TITLE OF PROJECT: Wharton – Masonry Restoration to SW Exterior Stairs (FY24)

PROJECT NUMBER: CP23026

ADDENDUM NO: 01

OWNER:	Michigan State University 113 Student Services East Lansing, MI 48824
ARCHITECT:	Fishbeck 39500 MacKenzie Drive, Suite 100 Novi, MI 48377
DRAWING REVISION NO.:	A1
ISSUED HEREWITH:	
SPECIFICATION SECTIONS:	07 21 00
SHEETS:	DA-1, A-1, A-3, S-1, P-1, P-2
BIDS DUE:	January 24, 2024
This Addendum is issued to all Bid Set Holders, is a part of the Contract Documents, and modifies the previously issued Bidding Documents. Acknowledge receipt of this Addendum in the space provided on the Bid form; failure to do so may result in rejection of the Bid.

PARTIAL FIRST FLOOR PLAN
SCALE: 1/8" = 1'-0"

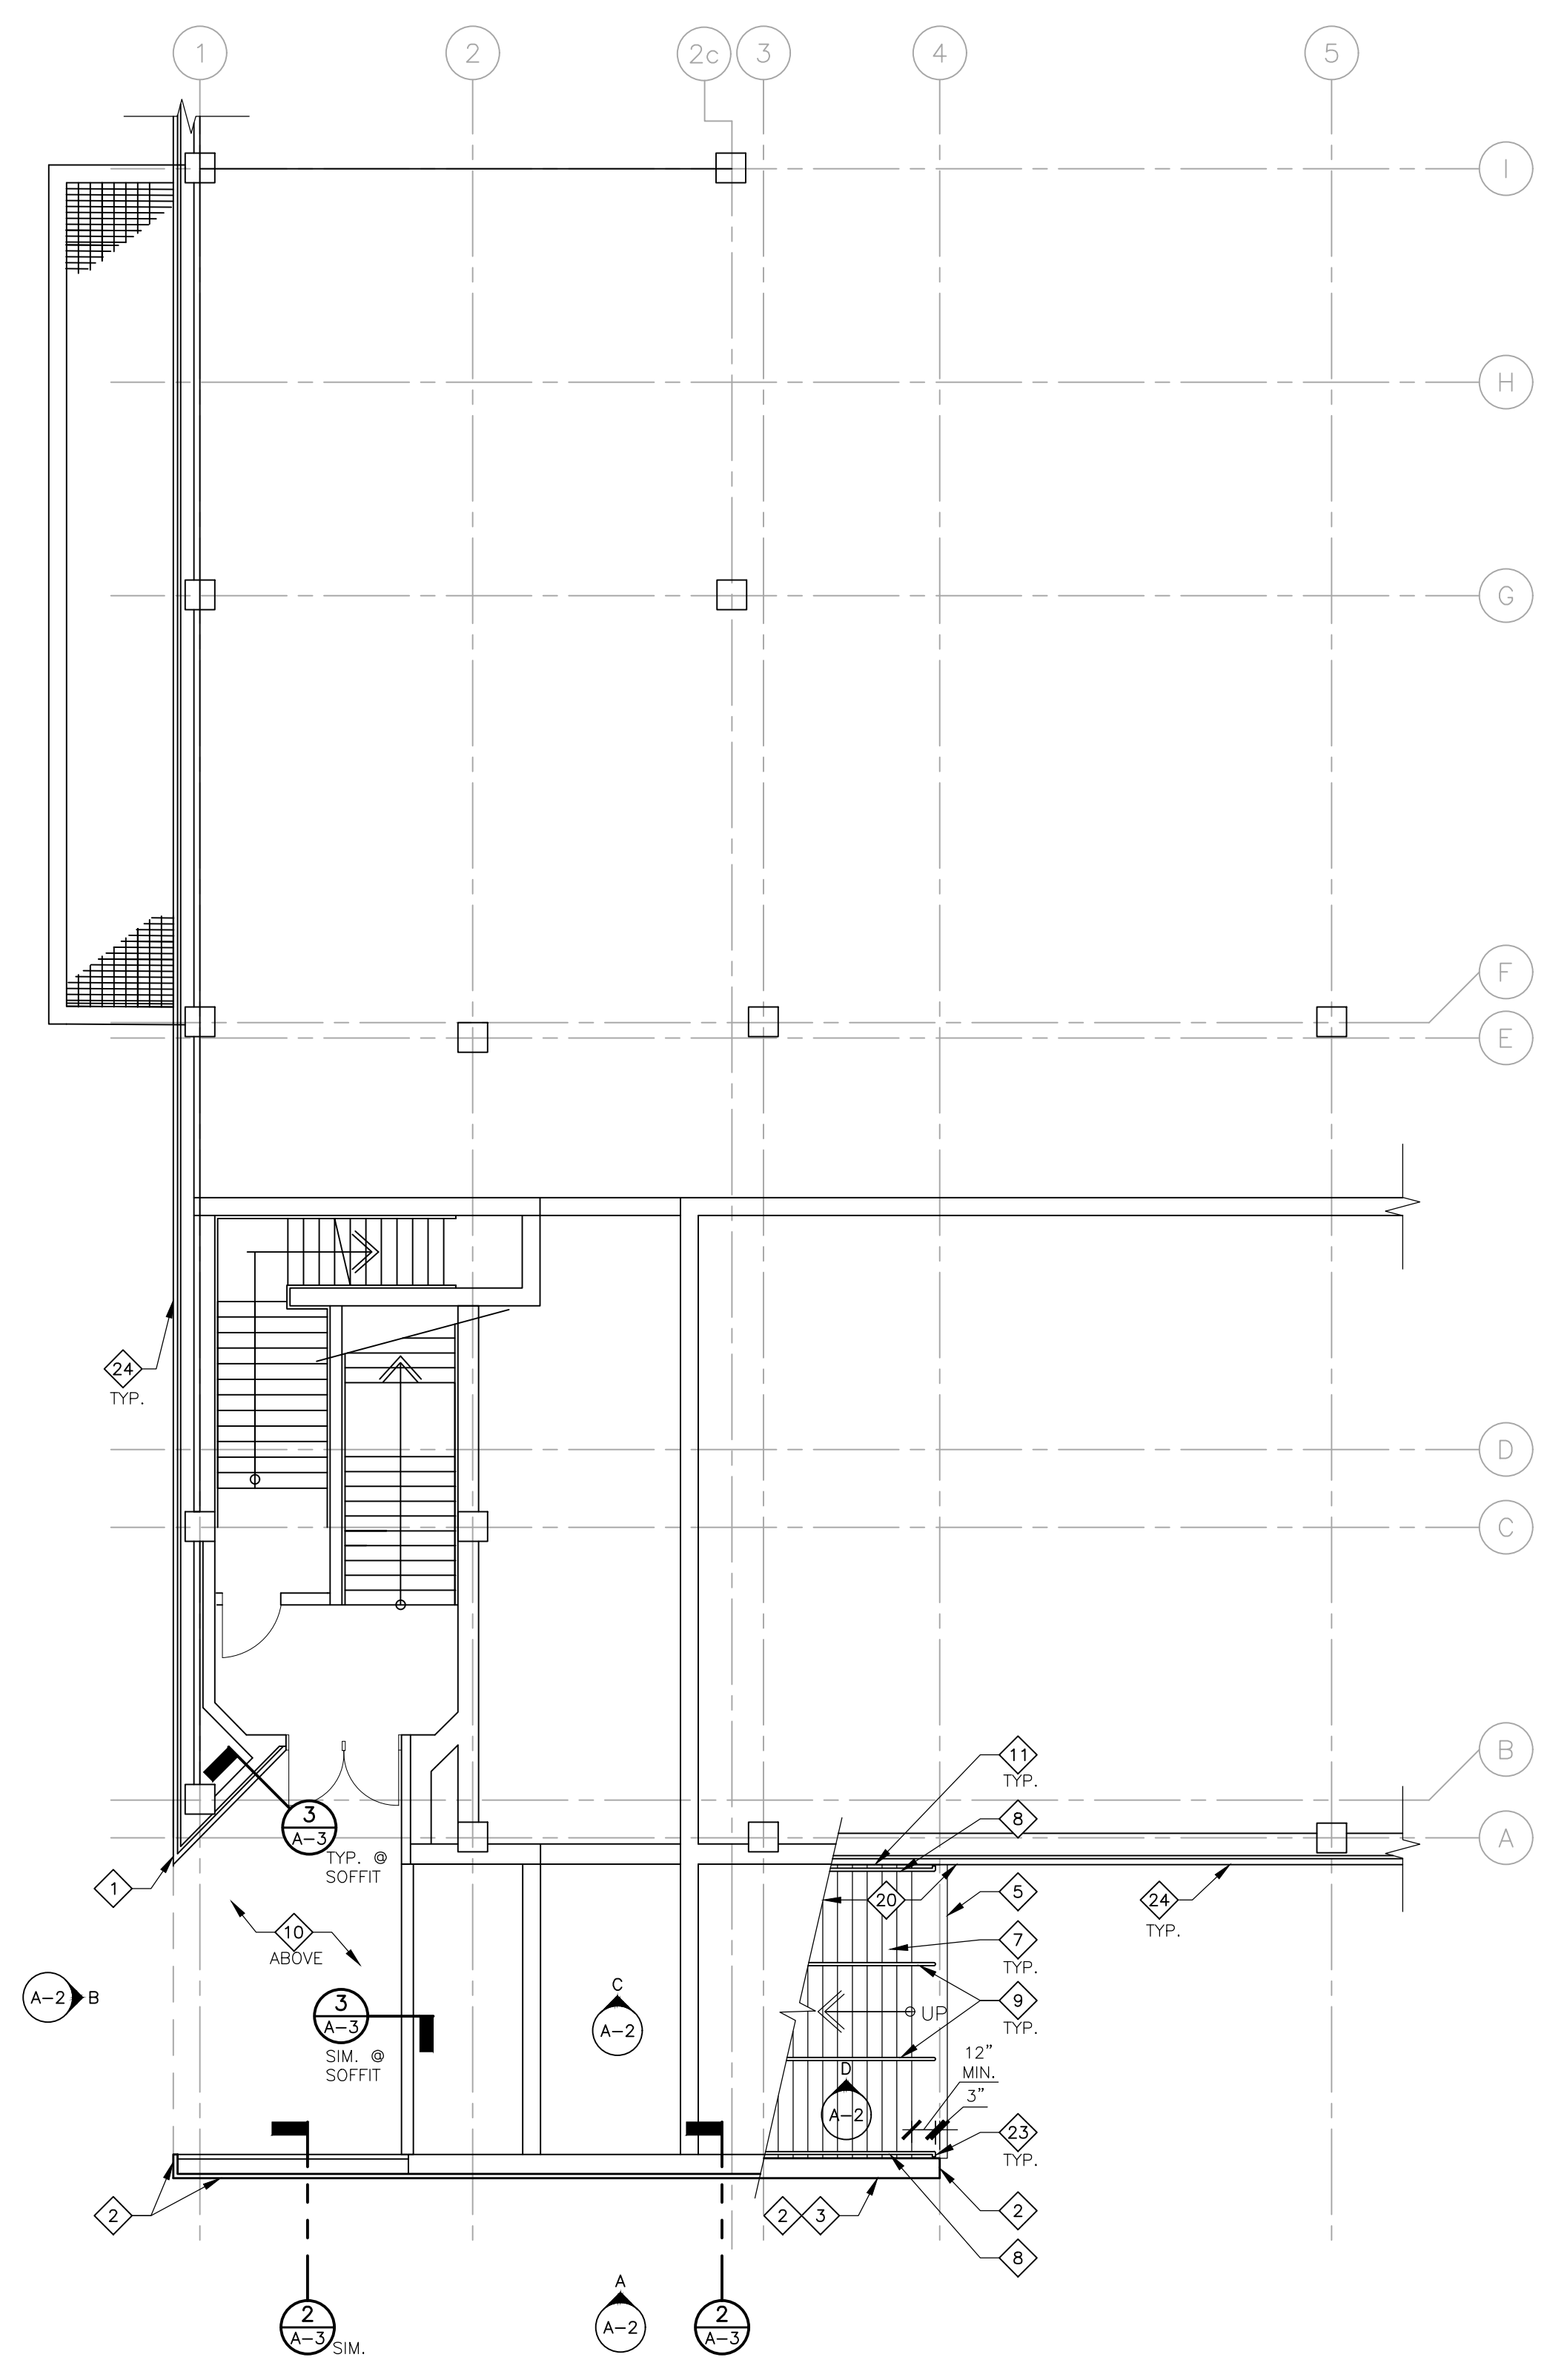
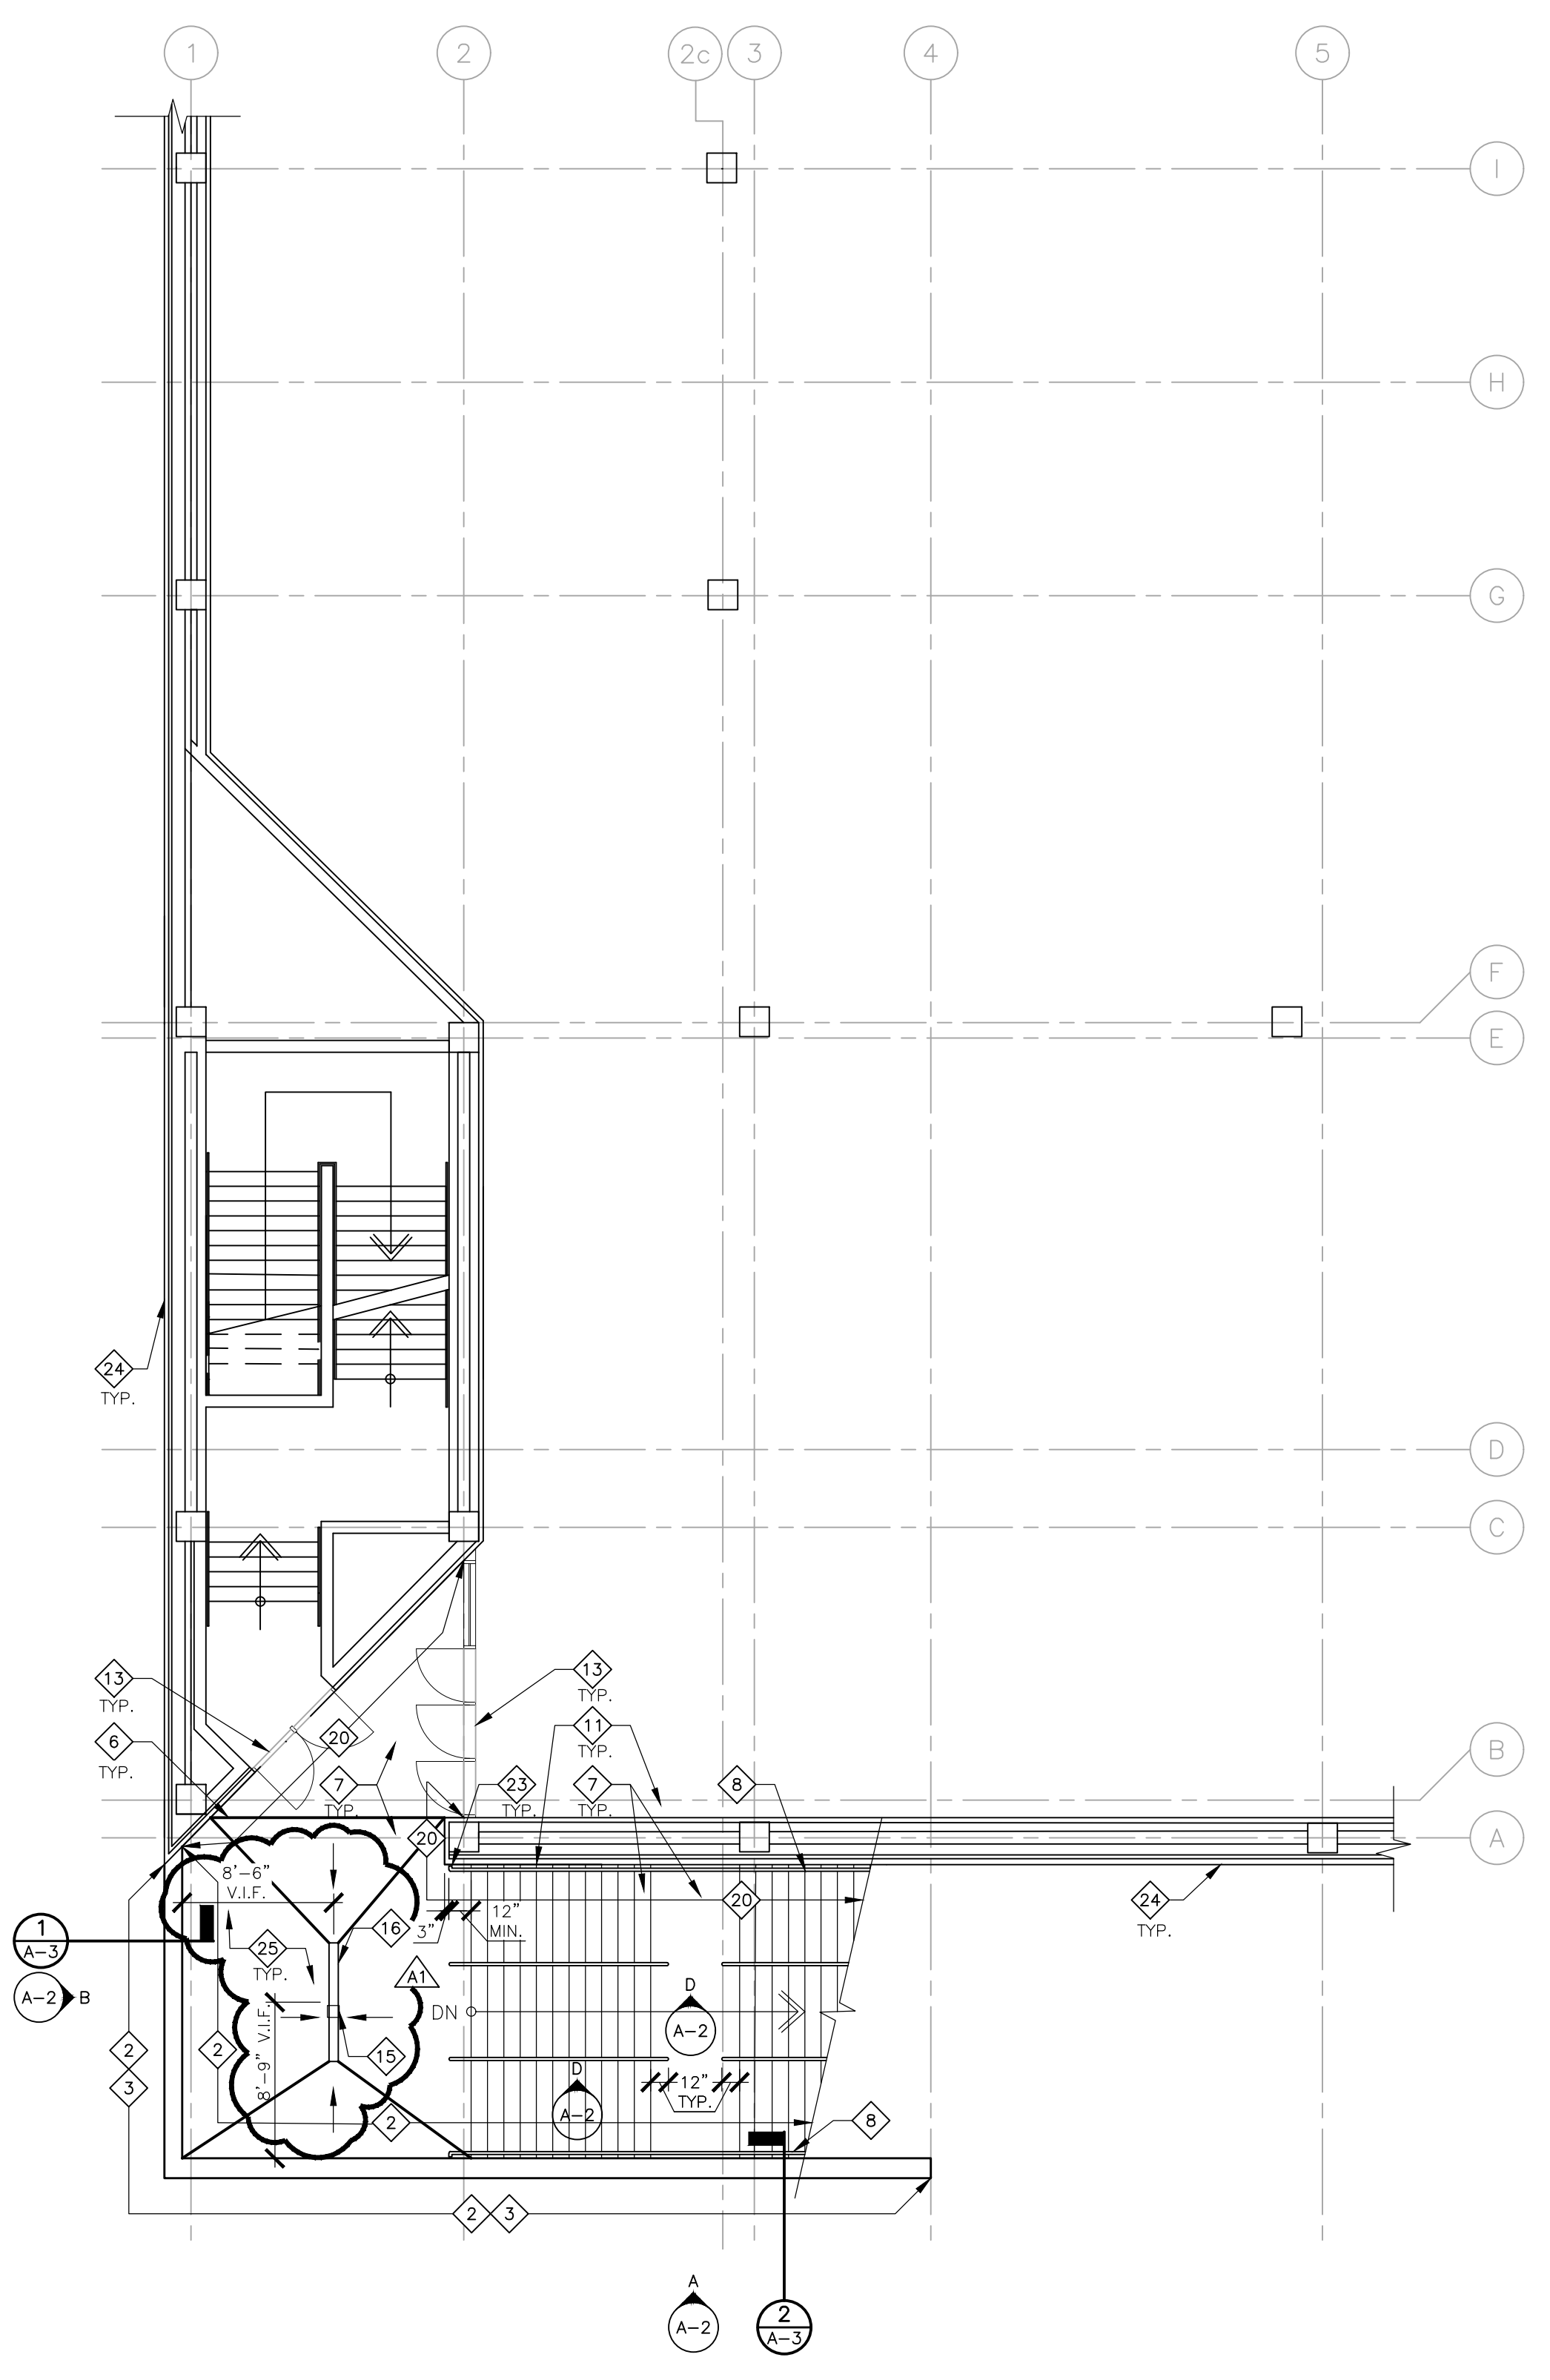
- A. Added new Specification Section 07 21 00.
- B. Clarified in architectural drawings the location of under slab insulation to be replaced.
- C. Clarified in architectural demolition drawings the location of under slab insulation to be removed.

- A. Revised architectural, structural, and plumbing drawings to remove two (2) AD-1, area drains, replace with one (1) TD-1, trench drain, and revise associated sanitary pipe. Revise Fixture Schedule to remove AD-1 and add TD-1.
- B. Clarified in structural drawings that if landing elevations or field conditions differ from what is illustrated within the drawings to notify engineer and to not proceed with drain installation.
- C. Clarified in architectural drawings the location of under slab insulation to be replaced.

15. INFILL SUB-SLAB WHERE EX. AREA DRAIN WAS REMOVED, REFER TO STRUCT.
16. NEW LINEAR AREA DRAIN, FIELD VERIFY DRAIN LOCATION SO AS TO NOT LOCATE AT SUB-SLAB BEAM / STRUCT., REFER TO PLUMB. FOR ADDITIONAL INFORMATION AND REFER TO AND STRUCT. FOR EXISTING CONDITION REQUIREMENTS ADDITIONAL PROCEDURAL REQUIREMENTS.

25. NEW 2" RIGID SLAB INSULATION, INSTALL INSULATION AT SAME LANDING LOCATIONS AS REMOVED INSULATION (ABOVE EX. SLAB TO REMAIN AND BELOW NEW CONCRETE LANDING).
